TOWN OF TIBURON
1505 Tiburon Boulevard
Tiburon, CA 94920

Design Review Board Meeting
February 4, 2016
Agenda Item: **3**

STAFF REPORT

Subject: 2370 Paradise Drive; File No. VAR2015023/DR2015148; Site Plan and Architecture Review for Construction of a New Single-Family Dwelling, with Variances for Excess Lot Coverage and Excess Fence Height

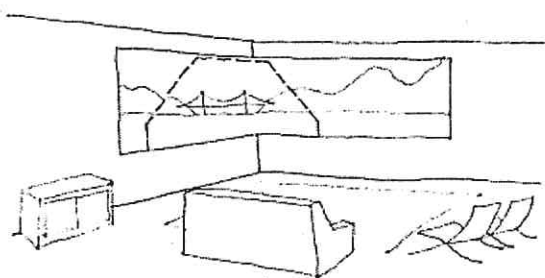
The profile of the proposed house would be similar to that of the existing house on the site. Most of the roofline would not exceed the height of the existing house and the proposed dwelling would not extend beyond the footprint of the existing structure in locations that would affect views from neighboring properties. The roofline would not appear to intrude into views from any homes uphill from the site. The lot directly across the street from the subject property is currently vacant, but future development of this site would likely be similar to that of other homes on this side of Paradise Drive, which have been designed to capture views at higher floor levels above the homes across the street.

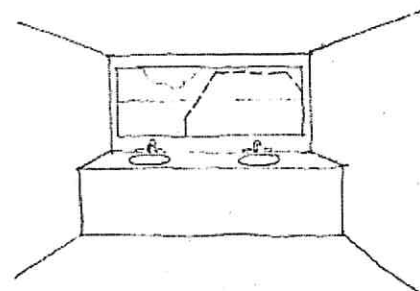
The proposed house design would include an angled roof over the living room, dining room and kitchen that would be raised above the height of the remaining roofline at the rear. This raised angled roof would be most visible from the neighboring home to the east at 2380 Paradise Drive. The following principles of the Hillside Design Guidelines should be used in evaluating the potential view impacts from this neighboring home:

Goal 3, Principle 7 (A) of the Hillside Design Guidelines states that “view protection is more important for the primary living areas of a dwelling (e.g. living room, dining room, family room, great room, kitchen, and decks associated with these rooms) than for less actively used areas of a dwelling (e.g. bedroom, bathroom, study, office, den).” The raised roofline would intrude into the views from the kitchen and dining room of the home at 2380 Paradise Drive.

• PROPOSED STRUCTURE
BLOCKS LIVING ROOM VIEW

• GREAT IMPACT ON
LIVABILITY

• PROPOSED STRUCTURE
BLOCKS BATHROOM VIEW

• LITTLE IMPACT ON
LIVABILITY

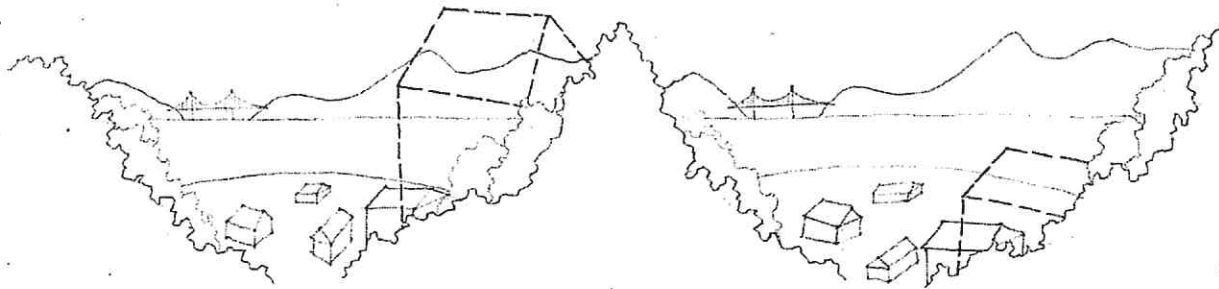
Goal 3, Principle 7 (C) of the Hillside Design Guidelines states that “horizon line is [the] most sensitive part of [a] view, then foreground, then middleground. If possible, avoid cutting [the] horizon line of a neighbor’s view.” The proposed raised roofline would cut

into the horizon line of the Marin Headlands and below the Golden Gate Bridge for the home at 2380 Paradise Drive.

6. BLOCKAGE OF CENTER OF VIEW MORE DAMAGING THAN BLOCKAGE OF SIDE OF VIEW.

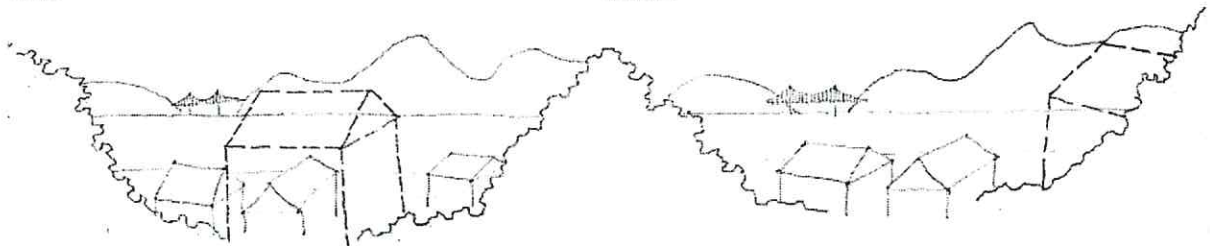
Goal 3, Principle 7 (C) of the Hillside Design Guidelines states that “blockage of center of [the] view [are] more damaging than blockage of [the] side of [the] view.” The raised roofline would intrude into the far right side of the view from the home at 2380 Paradise Drive.

• PROPOSED STRUCTURE
BLOCKS CENTER OF VIEW

• PROPOSED STRUCTURE
BLOCKS SIDE OF VIEW

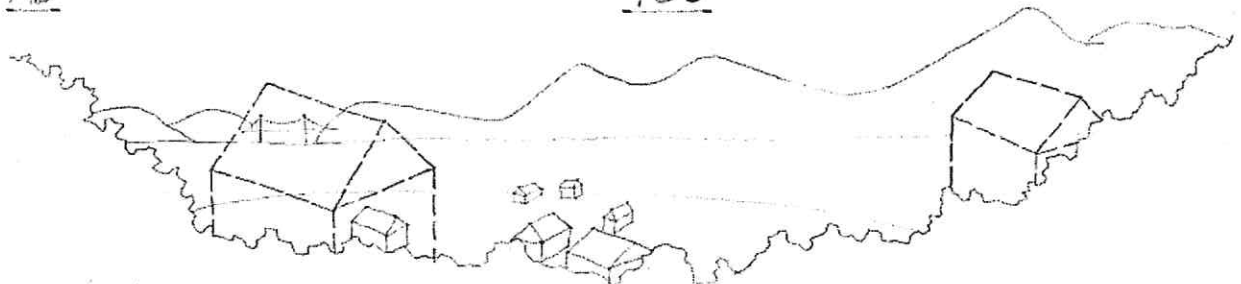
Goal 3, Principle 7 (D) of the Hillside Design Guidelines states that “blockage of important object in the view (Golden Gate Bridge, Belvedere Lagoon, Sausalito, Angel Island) is more difficult to accept than blockage of other, less well-known landmarks.” The raised roofline would intrude into the views of the Golden Gate Bridge from the kitchen of the neighboring home.

The lower portion of the roof of the proposed house would not appear to create the same view issues as the raised roofline. The story pole representing the lower roof above the proposed study would be similar to the profile of the existing house. Reducing the roofline above the living room, dining room and kitchen would likely alleviate this view concern.

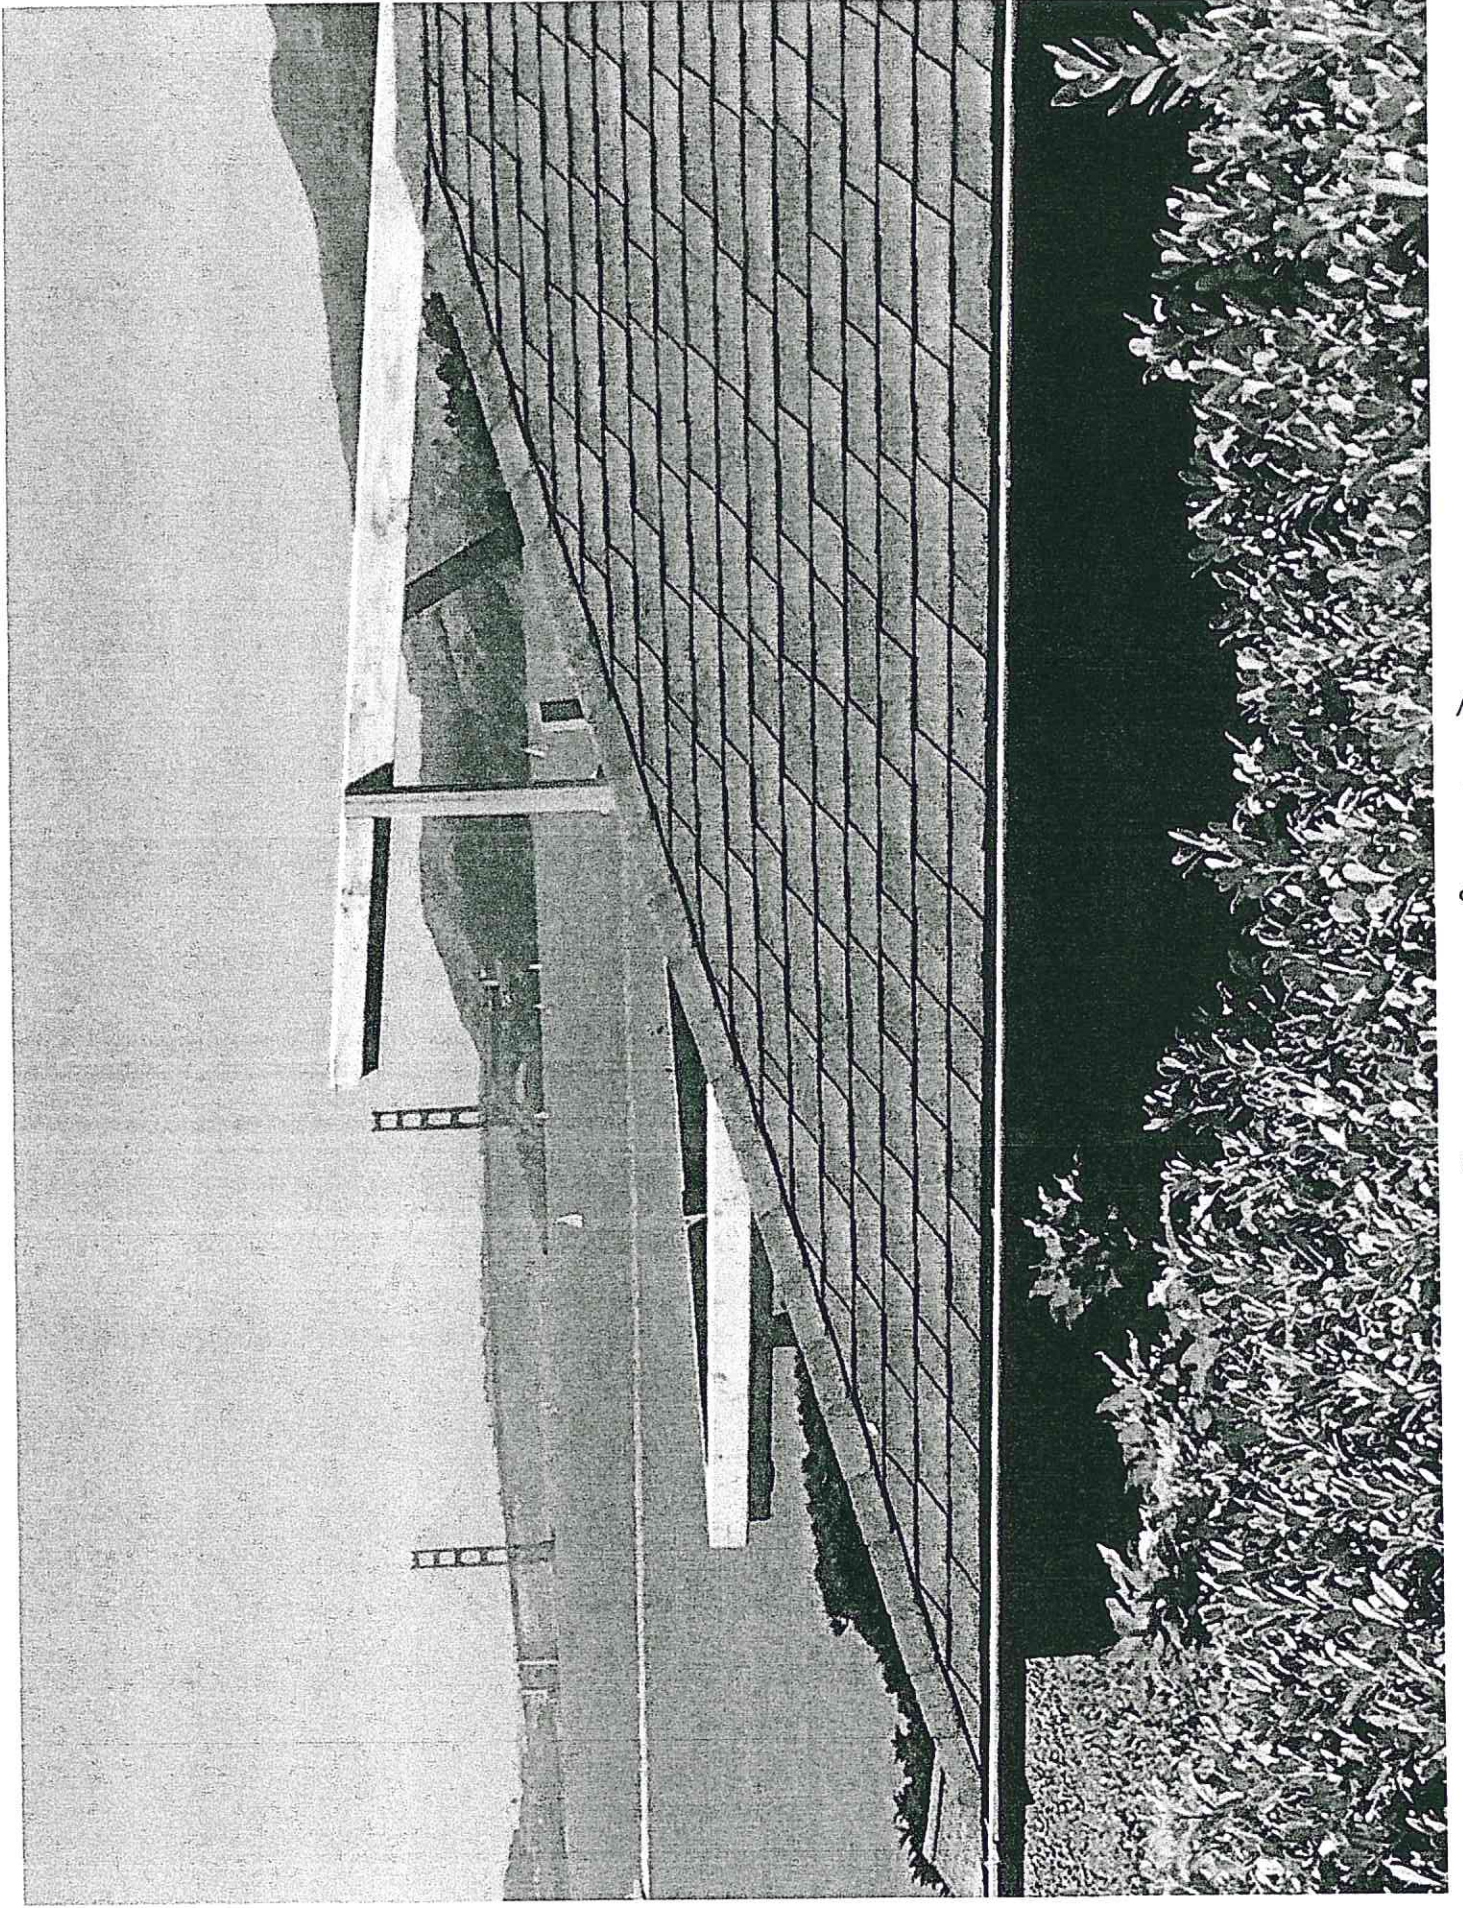
PARADISE DRIVE PARKING – Vehicles parked in our neighbor's parking pad too close to the end of our driveway obstruct our view of approaching cars and bicycles when we back out onto Paradise Drive. It is important that parked vehicles be able to pull completely off the road and not be able to pull up too close to our driveway. Some type of barrier to prevent parking close to our driveway would be good. There used to be a thick privet hedge at the end of the pad that prevented this. We have included a picture taken from our driveway of a truck parked in our neighbor's parking pad to illustrate the problem.
